Southern Nuclear Operating Company  
Vogtle Early Site Permit Application  
Response to Request for Additional Information Letter No. 11  
Involving Groundwater

**Response to NRC RAI Letter No. 11**

**for the Vogtle ESP Application**

**Involving Groundwater**

Figure 1 - Wetlands on the tributary to Daniels Branch west of proposed Units 3 & 4 and boundary conditions used in the groundwater model.

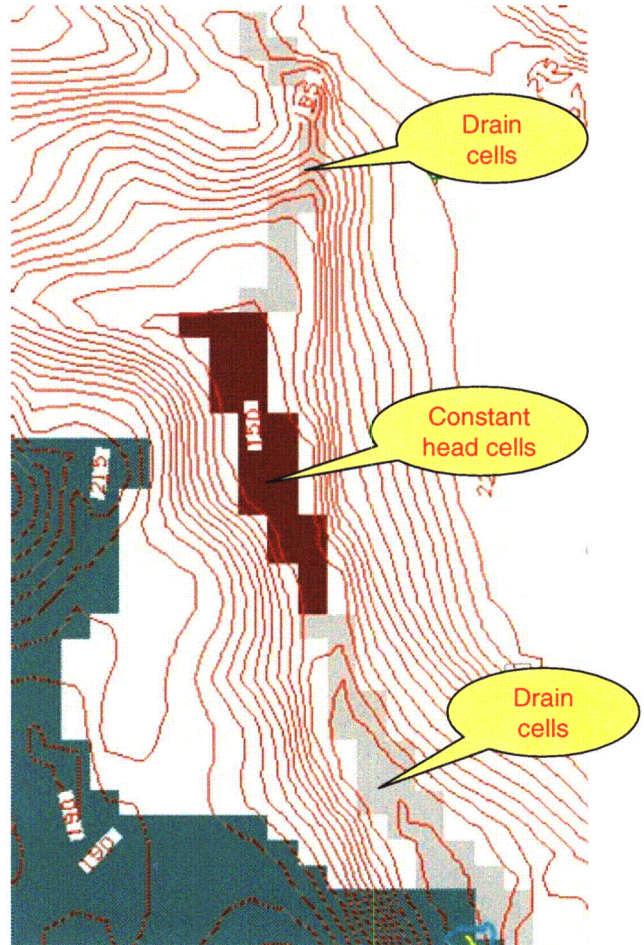
**The model should also better simulate flow associated with the tributary to the Daniels Branch. According to the wetland report submitted by Southern (see January 2007 submittal), the tributary to Daniels Branch that lies to the west of the cooling tower area includes segments of an ephemeral stream (adjacent to OW-1007), wetland, and a perennial stream. The perennial stream is upstream of Lower Debris Basin 2. The baseline model could exhibit groundwater flow toward each of these segments of the stream during the wetter period of the year (e.g., March); determine whether it should do so for the perennial stream segment as well. In the real setting based on groundwater observations, groundwater flow occurs from the proposed cooling tower area to the tributary to Daniels Branch; however, in the simulated setting it does not. Furthermore, the potentiometric surface shown for Model 7 (see Figure 50) suggests that groundwater flow occurs across or through the streambed and continues in a northerly direction even though the topographic data suggests the streambed is below the groundwater level in this vicinity. To the extent that the groundwater model does not appear to acknowledge the presence of the streambed, assess whether the perennial stream segment may be better represented by a constant head boundary condition rather than a "drain."**

2. The tributary to Daniels Branch, located west of proposed Units 3 & 4, was represented by a combination of drain and constant head cells (Figure 1). Most of the streambed of this tributary is represented by drain cells. The drain elevation at these cells was set equal to the stream invert elevation based on topographic data. A pond exists upstream of Debris Basin # 2. This pond was most likely created by a beaver dam. A photograph of this pond taken on April 22, 2008 is shown in Figure 2. It is noted that no rainfall had been recorded in the 30 days prior to that date. This pond can also be seen in aerial photographs of this area, suggesting that it is a permanent feature. Therefore, the area of the pond was represented in the model by constant head cells at elevation 150 ft.

Figure 3 - Recharge zones used in the baseline groundwater model

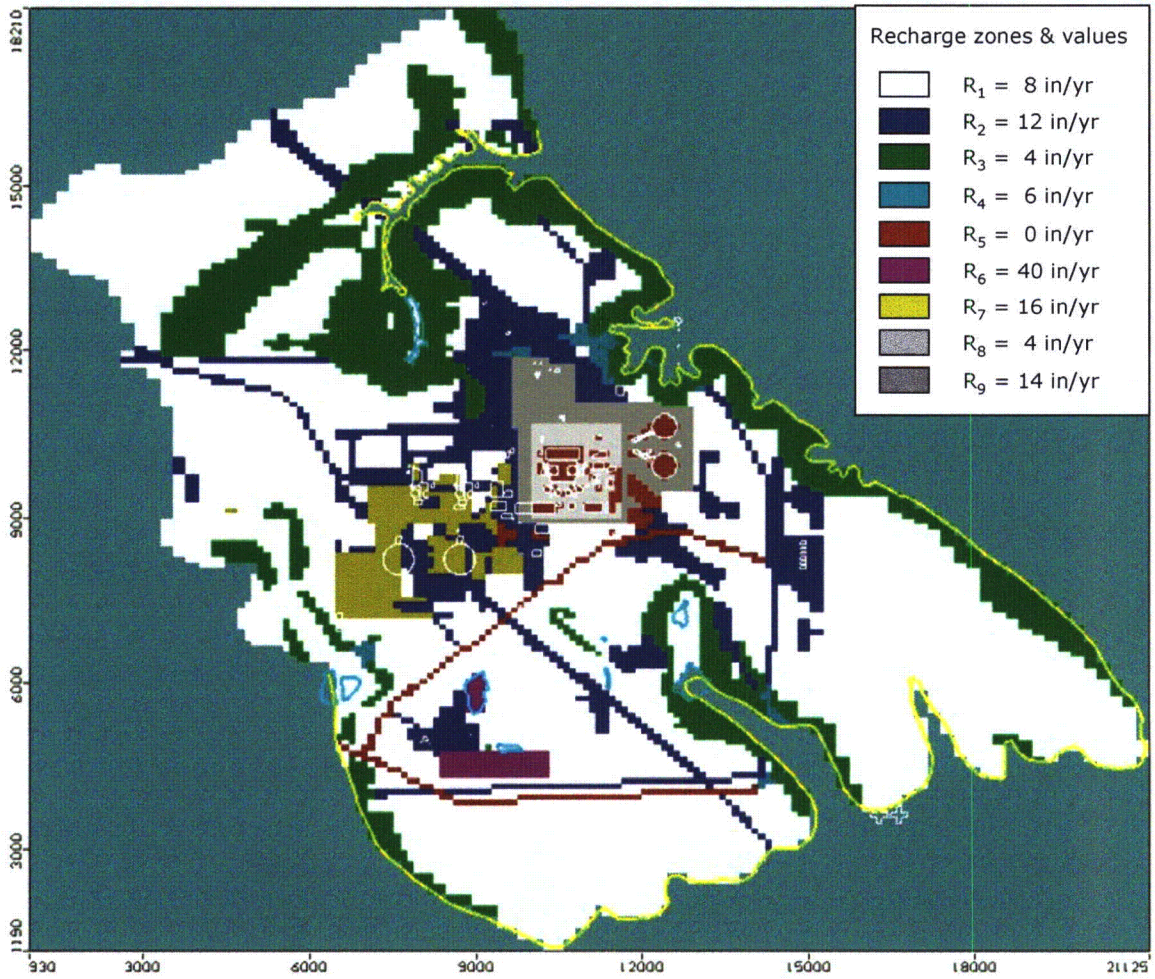
**2.4.12-5 Provide a version of the baseline groundwater model (i.e., the model of the existing water table aquifer) that better accounts for the field data concerning both (1) the known groundwater high (which lies below the proposed cooling towers) and (2) the topography and flow around the tributary to Daniels Branch (which is to the west of the cooling tower area proposed for Units 3 and 4). The model should provide a plausible conservative representation of the real system in order to address whether changes in the hydrology necessary to cause a shift in the groundwater flow path are plausible.**

3. Three new recharge zones were introduced in the model (see Figure 3):
  - Nearly horizontal areas covered with gravel, which are expected to have relatively higher recharge than horizontal areas, and areas on mild slopes with grass. This zone is mostly around the area of Unit 3 & 4, which served as the construction yard for Units 1 & 2 (zone R<sub>7</sub> in Figure 3).

- Nearly horizontal but well drained areas around the power block of Units 1 & 2, where runoff is collected and recharge is expected to be relatively low (zone R<sub>8</sub> in Figure 3).

- Nearly horizontal graded areas with compacted gravel around Units 1 & 2 (e.g. the switchyard area), where recharge can be high, but less than in areas where the gravel has not been compacted (zone R<sub>9</sub> in Figure 3).

Figure 9 - Recharge zones around Units 1 & 2 and the proposed Units under present conditions.

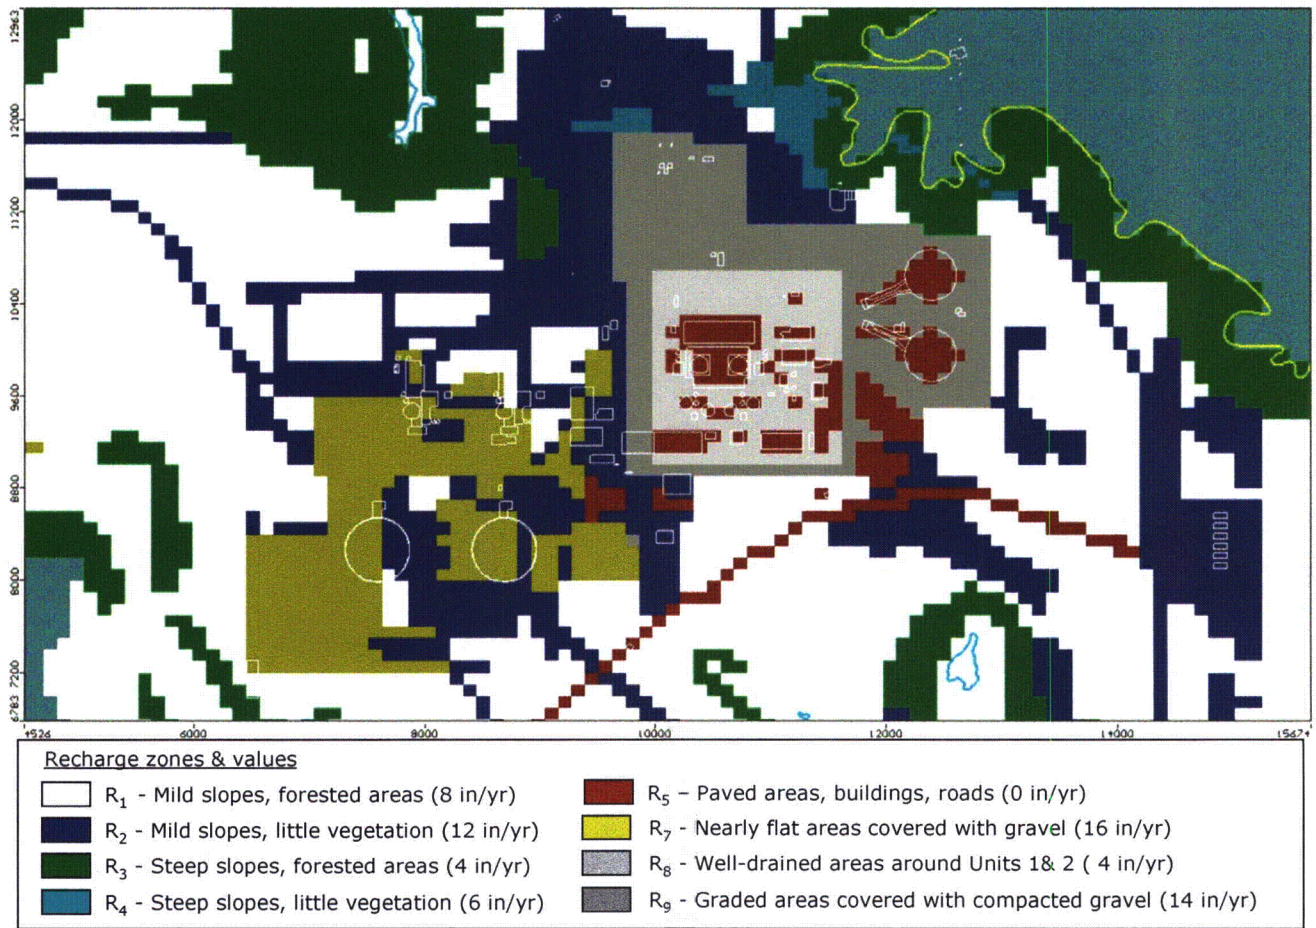
**2.4.12-6 Provide a further assessment of the assignment of infiltration rates, with special attention to the potential for higher infiltration in the immediate vicinity of the groundwater high that occurs beneath and adjacent to the proposed cooling towers for Units 3 and 4. The presence of highs or lows in the potentiometric surface of an aquifer suggests sources or sinks of groundwater, respectively. In the case of a broad region of uniform hydraulic conductivity, the presence of a groundwater high suggests a topographic high or a greater amount of infiltration. The region of interest is an area that was reshaped during construction of the existing units, and as a result is relatively flat and may present an opportunity for minimal runoff and maximum recharge. In addition, the presence of asphalt roadways and concrete pads may contribute to runoff to areas prone to infiltration (unlined ditches, water retention basins), with infiltration rates locally approaching if not exceeding precipitation because of the collection area aspect of ditches and basins.**

The first new recharge zone (R<sub>7</sub> in Figure 9) covers most of the area that was reshaped during construction of the Units 1 & 2, and as a result is relatively flat, covered mostly with gravel, which may present an opportunity for minimal runoff and maximum recharge. Most of this area was used as the construction yard for Units 1 & 2.

Nearly horizontal graded areas covered with compacted gravel (e.g. the switchyard and other areas around Units 1 & 2) were defined as another recharge zone (R<sub>9</sub> in Figure 9). Recharge over this zone is high but less than zone R<sub>7</sub>.

Finally, an area of relatively low recharge was defined to describe the well-drained areas around the power block of Units 1 & 2 (R<sub>8</sub> in Figure 9).

Using these new recharge zones with the values indicated in Figure 9 contributed to the improved calibration of the groundwater model and its ability to simulate the local groundwater high that occurs beneath, and adjacent to, the proposed cooling towers for Units 3 and 4 (see Figure 6).

Figure 10 - Simulated heads and particle tracking for a hydraulic conductivity distribution that produces groundwater pathways to the south.

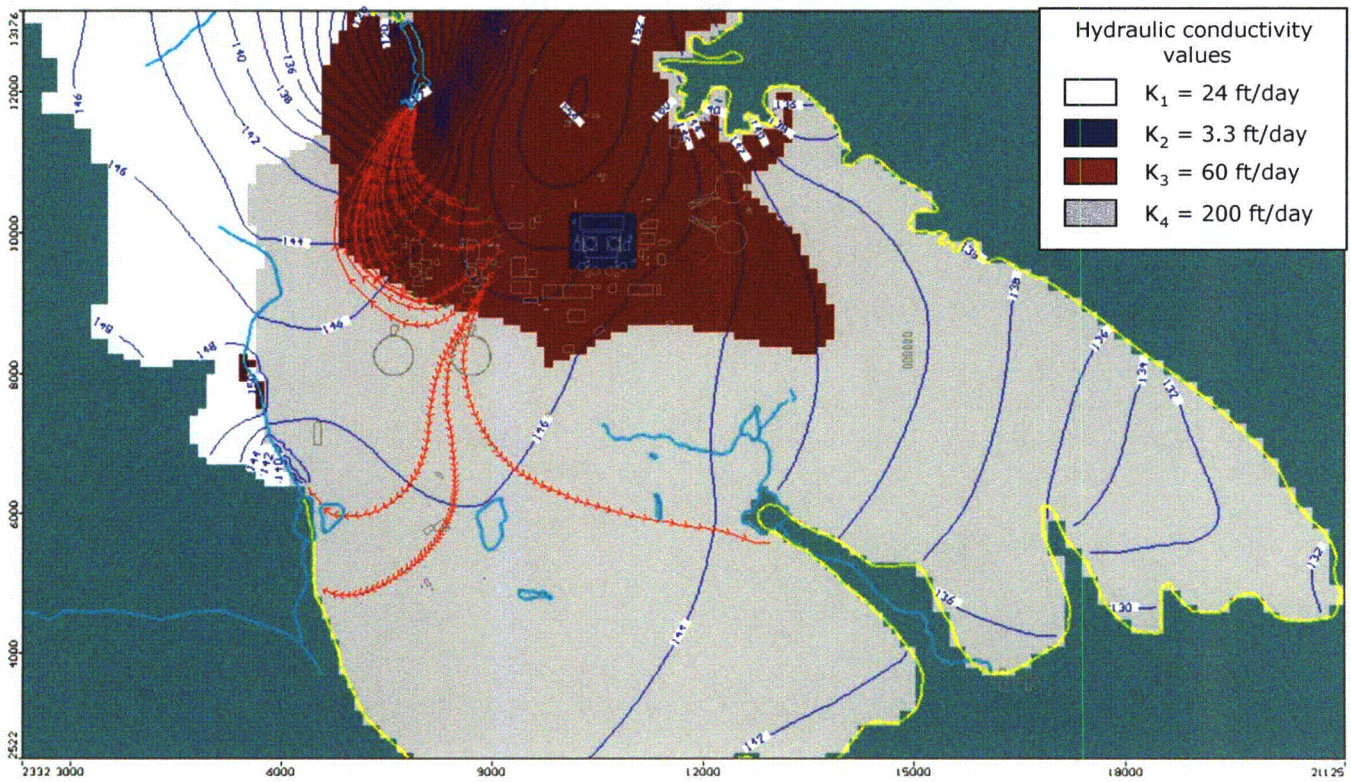
**2.4.12-7 Based on the revised baseline model incorporating the further assessment of infiltration rate assignments – i.e., the most plausible conservative conceptual model of today’s site – provide an analysis of (1) the magnitude of change in hydraulic conductivity, if any, that would cause a groundwater flow path to exist to the west or southwest from the power block area, (2) the spatial distribution and magnitude of infiltration rate changes, if any, that would cause a groundwater flow path to exist to the west or southwest of the power block area, and (3) combinations of the above.**

Figure 10 shows the hypothetical zones and values of hydraulic conductivity that would be required to produce some pathways to west and to the south. The introduction of such a high conductivity zone over the southern half of the model domain shifts the groundwater high to the north of the power block of Units 1 & 2, and lowers overall water levels. The hydraulic conductivity of this hypothetical zone is 200 ft/day. The hydraulic conductivity values of all other zones and the groundwater recharge rates are the same as in the baseline case. Figure 11 compares the simulated and computed heads using the hydraulic conductivity distribution shown in Figure 10. As can be seen in Figure 11, this simulation substantially underestimates the measured heads. The root mean square residual is for this simulation is 11.008 ft, suggesting that this is not a plausible model.
